Stakeholder Comments Template

Resource Adequacy Enhancements

Submitted by	Organization	Date Submitted
Nuo Tang ntang@sdge.com	San Diego Gas & Electric	August 7, 2020

Figure 8: Short-Range Timelines (Thursday and Friday Holiday Example)

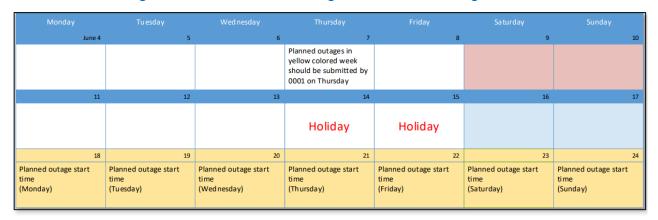
- The current planned outage threshold is 7 days prior to the start of the outage not including the day of the request and the day of the start of the outage. The planned outage defined by RC0630 has a minimum of 7 days but a maximum of 18 days prior to the start of an outage because all planned outages within one week are grouped together for the purposes of the short-range study. As shown in Figure 8 of the RC0630 operating procedures, an outage that starts on the 24th of June must be submitted effectively by midnight of the 6th to be considered as a Planned outage. If an outage is submitted past midnight of the 6th to start on the 24th, is this outage considered either an Urgent or Forced Outage?
